UNITED STATES  
NUCLEAR REGULATORY COMMISSION  
WASHINGTON, D.C. 20555-0001

SUBJECT: INDIAN POINT NUCLEAR GENERATING UNIT NOS. 2 AND 3 – STAFF  
ASSESSMENT OF RESPONSE TO 10 CFR 50.54(f) INFORMATION  
REQUEST – FLOOD-CAUSING MECHANISM REEVALUATION  
(CAC NOS. MF3313 AND MF3314; EPID L-2013-JLD-0031)

STAFF ASSESSMENT BY THE OFFICE OF NUCLEAR REACTOR REGULATION  
RELATED TO FLOODING HAZARD REEVALUATION REPORT  
NEAR-TERM TASK FORCE RECOMMENDATION 2.1  
INDIAN POINT GENERATING STATION, UNIT NUMBERS 2 AND 3  
DOCKET NOS. 50-247 AND 50-286

**Figure 3.1-2. Map Showing Features of the Indian Point Energy Center Powerblock in Relation to Local Topography. Source: Entergy (2014d)**

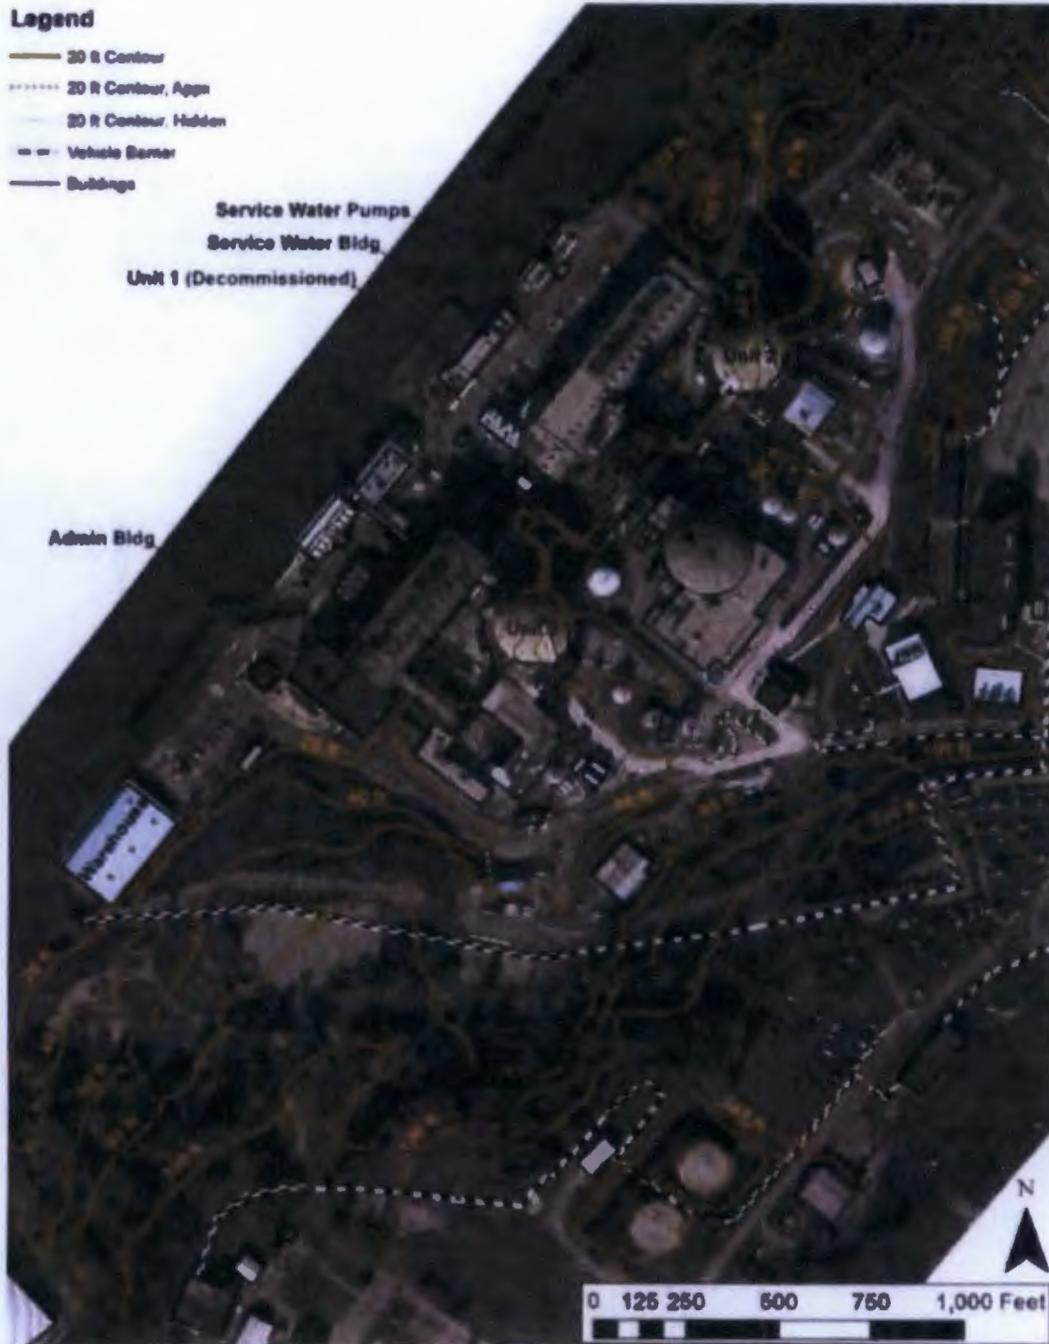
One of the issues raised during the review of the FHRR was the effect of the local topography on the accumulation of rainfall in and around the powerblock. As mentioned earlier, the topography of the area surrounding the site is steep and does not favor the infiltration of rainwater, especially during a high-intensity precipitation event. The potential for rainwater infiltration is further limited as the site is underlain by relatively impervious limestone substrate that would transform most precipitation into sheet flow. In evaluating the LIP flooding event, the licensee's FLO-2D modeling results indicated that there is the potential for supercritical flow to occur at two locations within the powerblock (Entergy, 2014e). The specific staff concern was that there would be the potential for backwater effects in and around the Unit 2 transformer yard during an onsite PMP event owing to a transition from supercritical to subcritical flow at the base of the northern-most service road siting adjacent to the Unit 2 transformer yard (NRC, 2018).

Because the FLO-2D computer code does not explicitly model hydraulic jumps that would occur during such a flow transition, the licensee attempted to evaluate the potential for backwater effects by preparing a supplemental analysis that estimated the potential of a likely hydraulic jump taking place in this general area; this supplemental analysis was discussed during the June 2015 audit. (See information need #5 in the audit summary (NRC, 2018)). The staff reviewed the information provided and agreed with the licensee's conclusion that any hydraulic jump that might form at the location in question would result in a small increase in downstream subcritical flow depth and as a consequence, any backwater effects in or around the Unit 2 transformer yard would be minor.

The staff also had questions about the treatment of the southeast corner location of the Unit 3 Transformer Yard in the licensee's FLO-2D computer model. The grid cells at the location in question (specifically ID Nos. 15051, 15052, 15299, 15300, 15548, 15549, 15798, 15799, 16049, and 16050) appeared to be elevated relative to other cells in the computer model; the staff had no information available to it to suggest that the grid cells corresponded to anything other than some type of as-built structure. As was the case with the Unit 2 Transformer Yard, the concern again was that there was the potential at this location to block surface flow entering the Unit 3 Transformer Yard again resulting in backwater effects in adjoining areas of the powerblock. During the June 2015 audit, the licensee presented aerial photographs that revealed that the grid cell locations in question corresponded to an existing structure associated with the Unit 3 Transformer Yard and that the orientation of the computer mode grid relative to this structure created the false impression that there was an obstruction. The staff concluded that the information provided by the licensee was sufficient to address its questions.

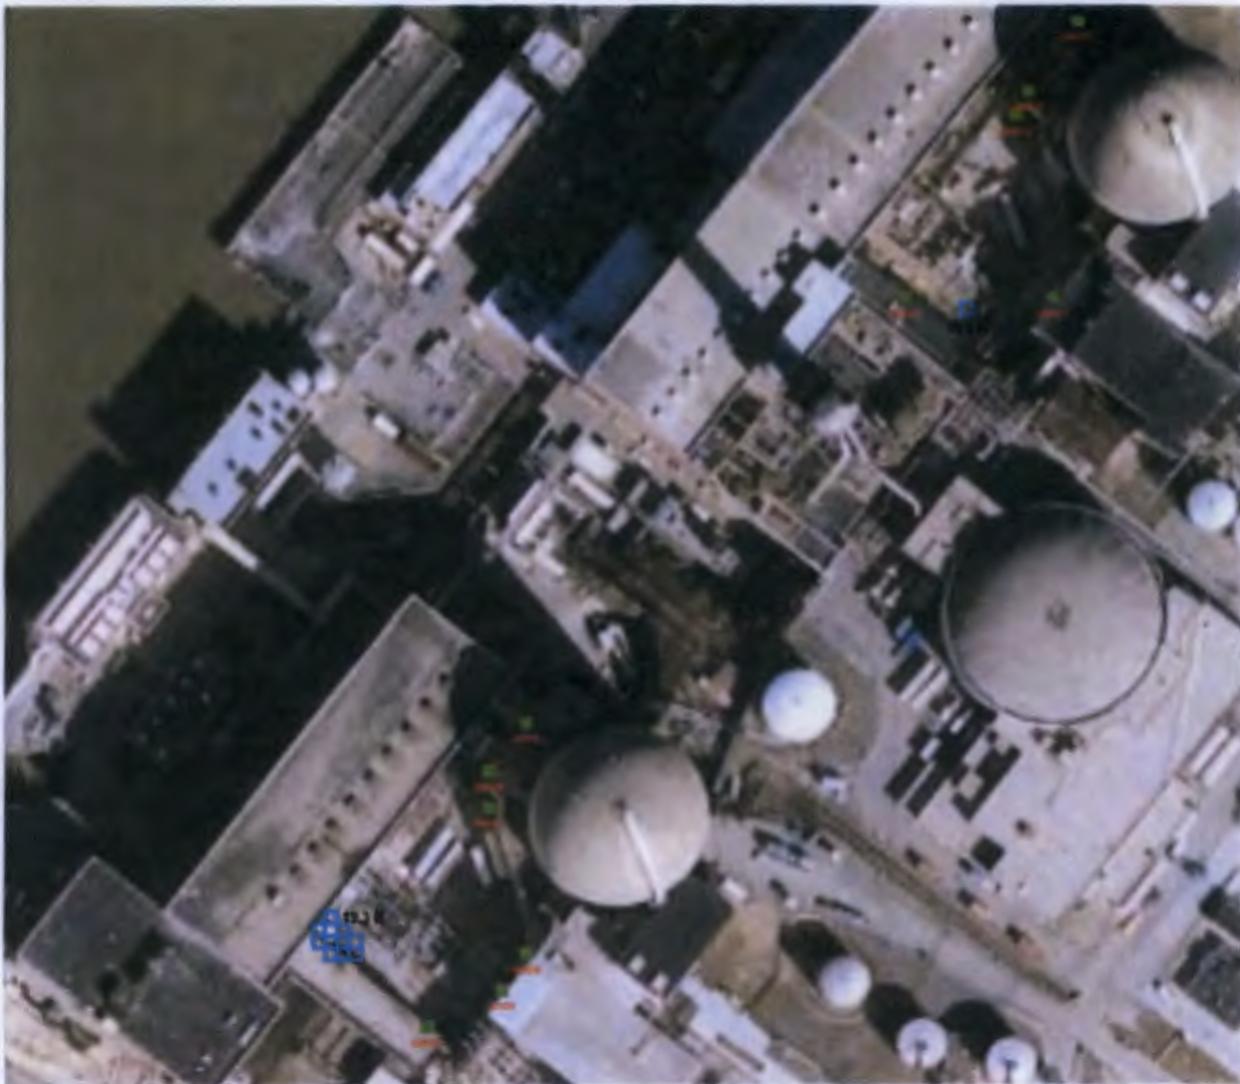
In October 2016, the licensee submitted its MSA for Indian Point (Entergy, 2016c) and in doing so reported a revised WSE for the LIP flood hazard for the purposes of the 50.54(f) request. The FLO-2D modeling results indicated that the maximum WSEs varied across the powerblock. For the Unit 2 transformer yard, the licensee was reporting a maximum WSE of 19.5 ft. NAVD29; in the Unit 3 transformer yard, a maximum WSE of 19.3 ft. NGVD29 was reported in the FHRR (Entergy, 2016c). These WSE values were previously calculated by the licensee in connection with its revised 2014 LIP flood analysis (Entergy, 2014a), but they did not occur at locations adjacent to critical door openings and thus were not reported as the maximum flood elevation for the purposes of the 50.54(f) response (Entergy, 2014c). See Figure 3.3-2 for a map of the maximum WSE locations.

The NRC staff further concluded that the maximum WSEs reported by the licensee were consistent with its confirmatory calculations. Therefore, the staff has determined that the methods described in the licensee's FHRR, the licensee's calculation package, and complementary submittals including responses to the staff's FHRR-audit questions are reasonable and consistent with present-day methods.
